OUTSTANDING DESIGN CONCERNS

PREVIOUS LUR 1 SUBMISSION - NORTH LANDSCAPE SITE PLAN: WHAT WE HEARD

LUR 2 - NORTH LANDSCAPE SITE PLAN RESPONSE

PREVIOUS LUR 1 SUBMISSION - SOUTH LANDSCAPE SITE PLAN: WHAT WE HEARD

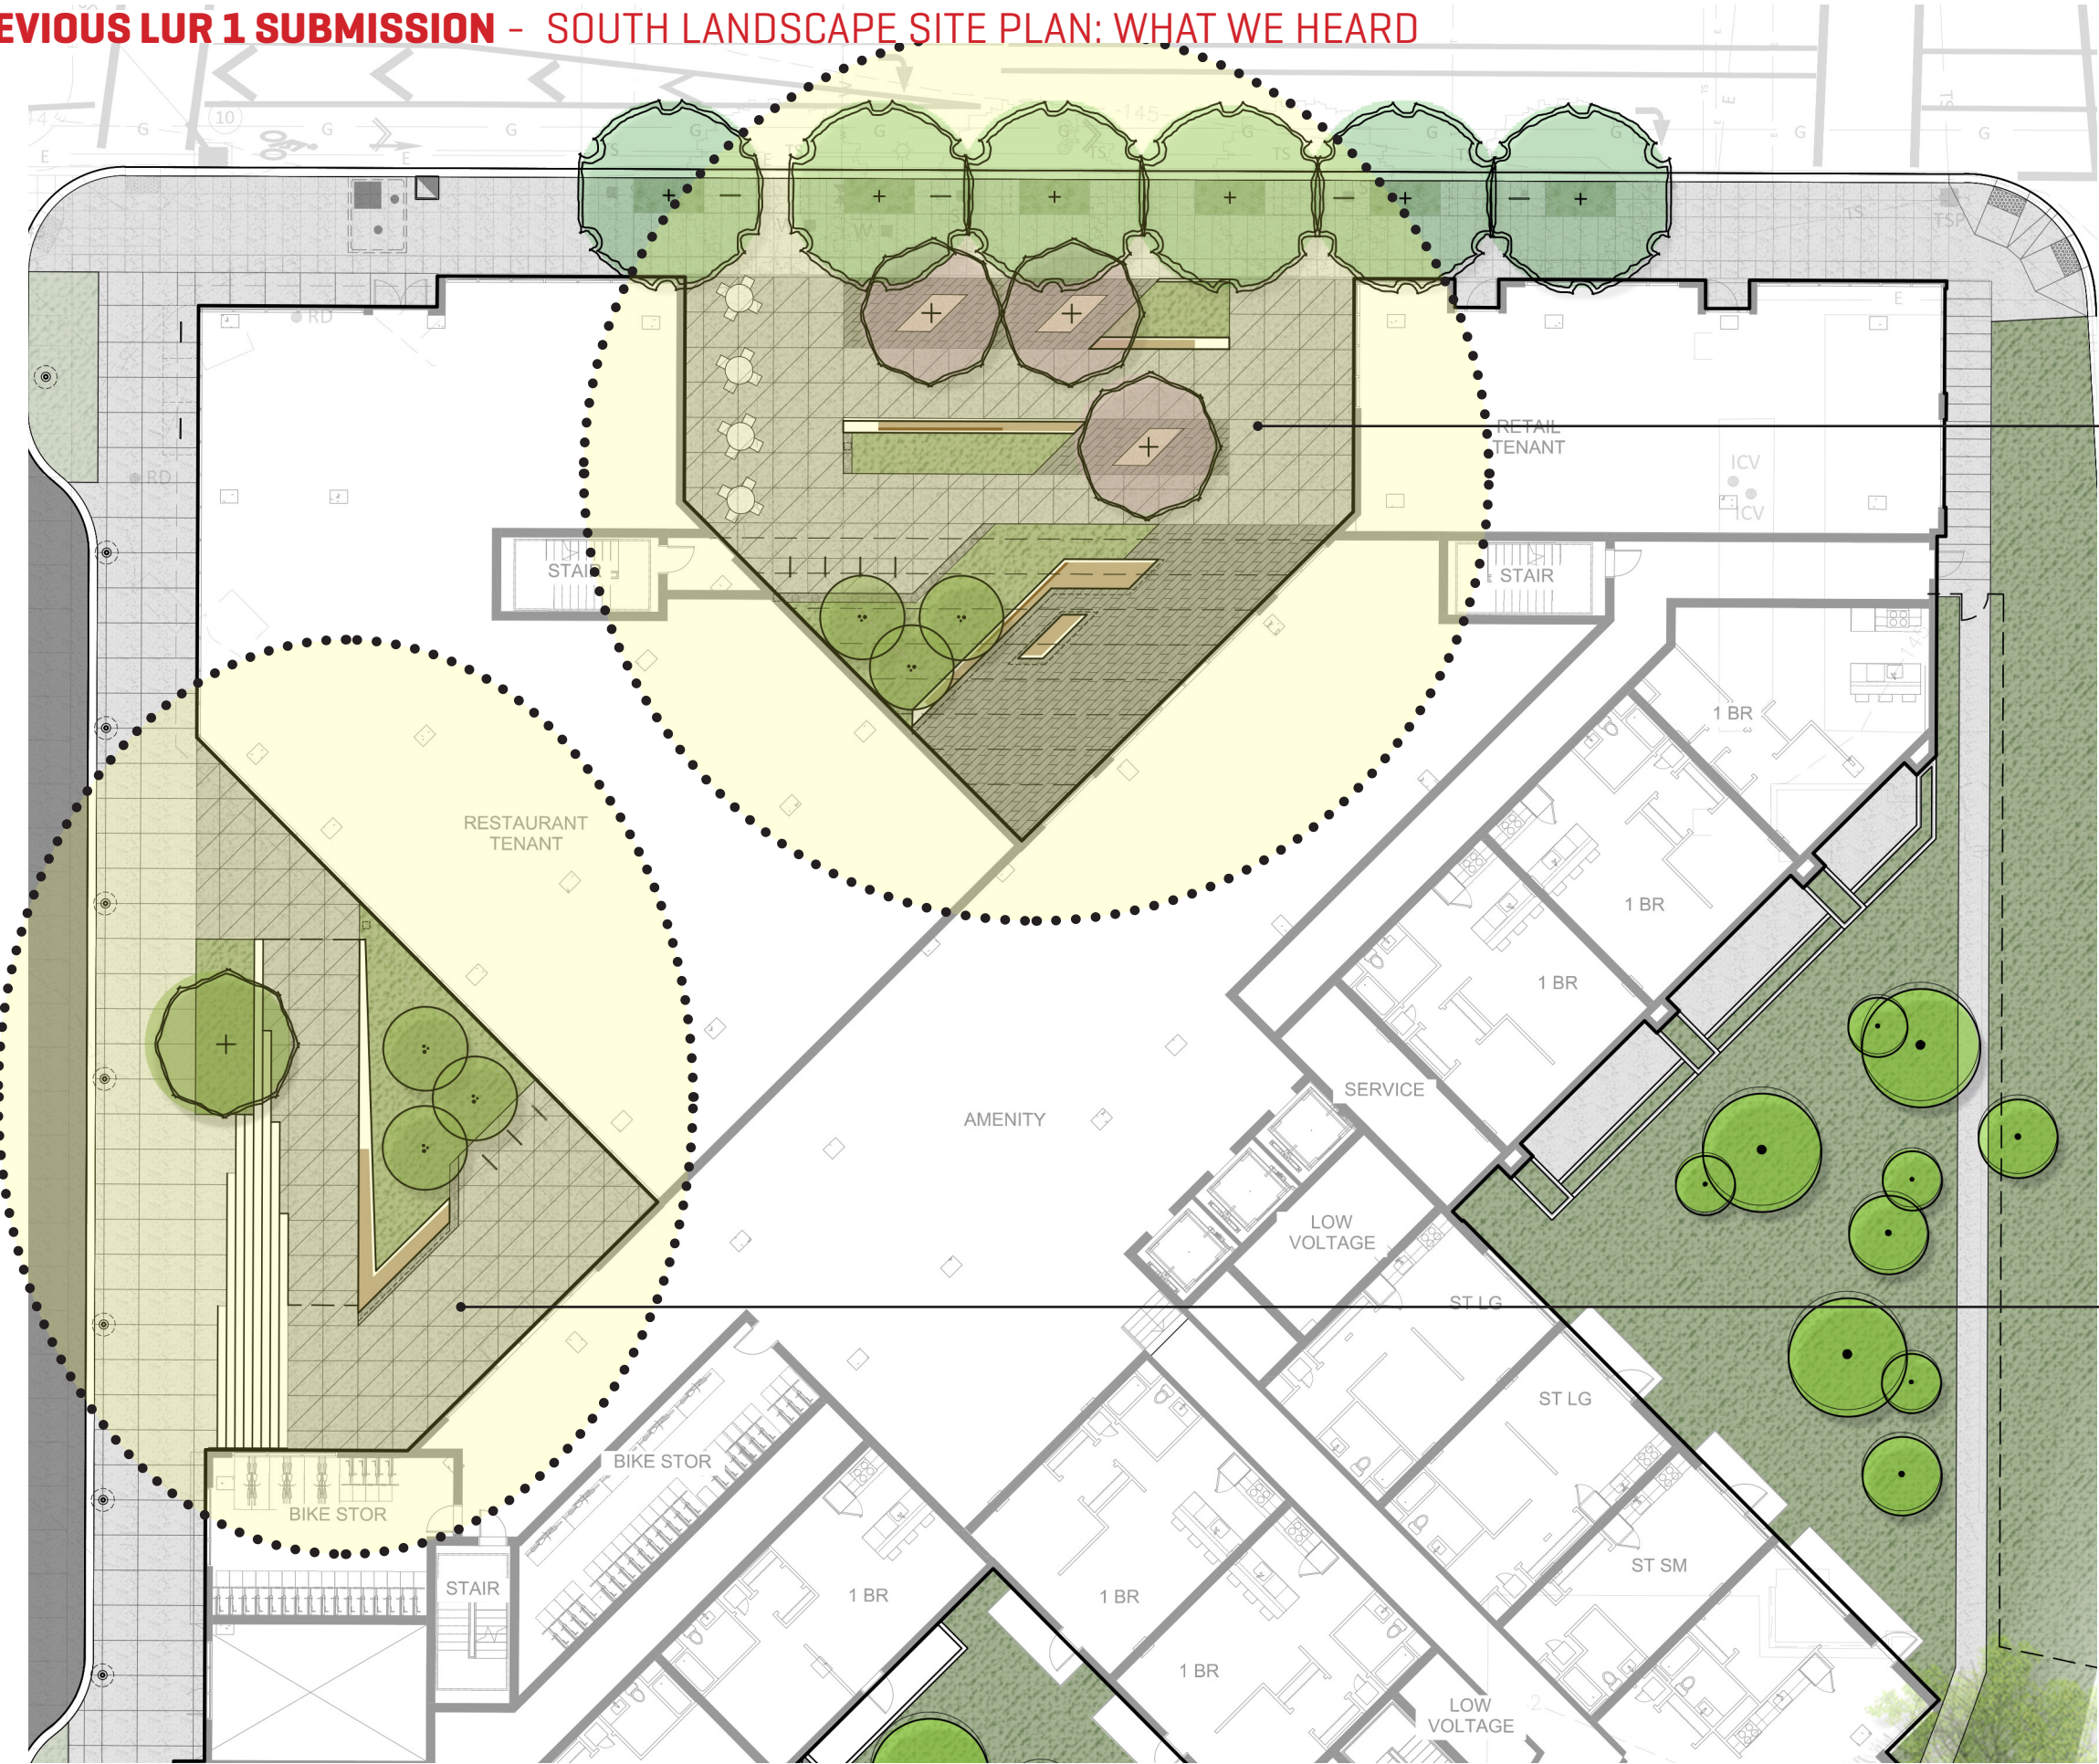
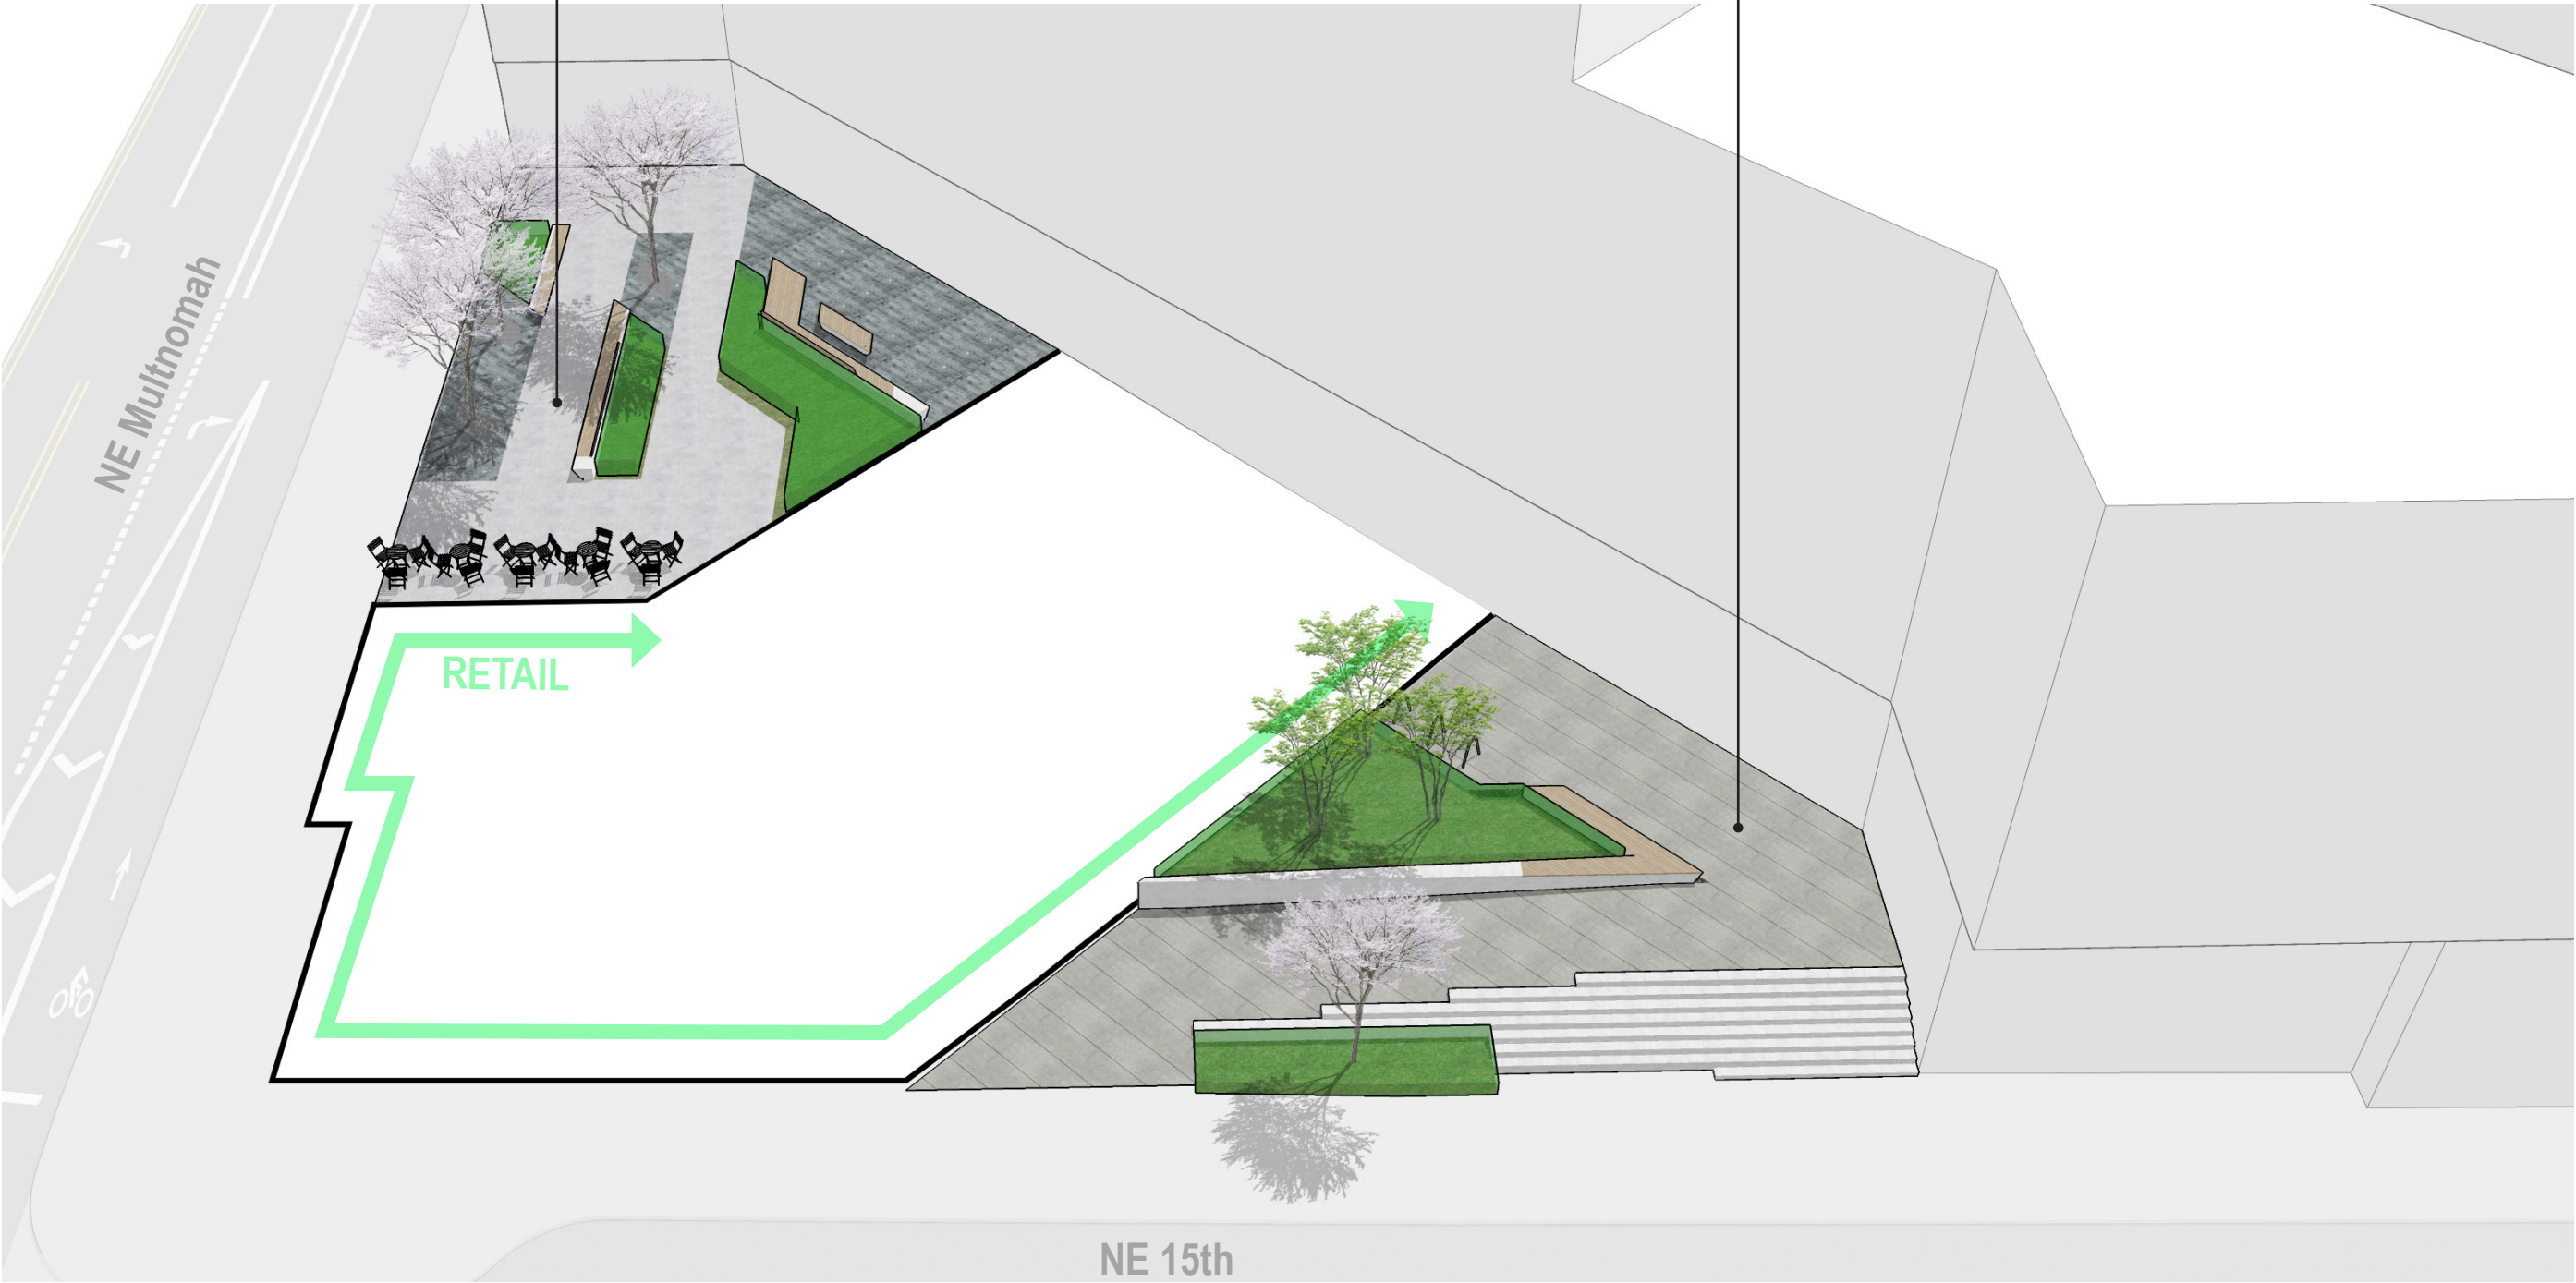
URBAN PLANE PLAZA
Courtyard layout and language doesn't seem quite 'baked'. Landscape design feels too tied to the geometry of the building - investigate some flexibility with layout language. Keep the benches.

PLATEAU PLAZA
Circulation path to Lobby seems too indirect. Linear bench feels like an obstacle and too sharp. Landscape design feels too tied to the geometry of the building - investigate some flexibility with layout language.

URBAN PLANE PLAZA
Landscape layout was simplified to create more flexibility of use and circulation throughout the space.

PLATEAU PLAZA
Landscape layout was simplified to create a more open terrace for the residential entry. Sharp points and barriers in the path of travel from 15th to the residential entry and retail back of house doors were eliminated.
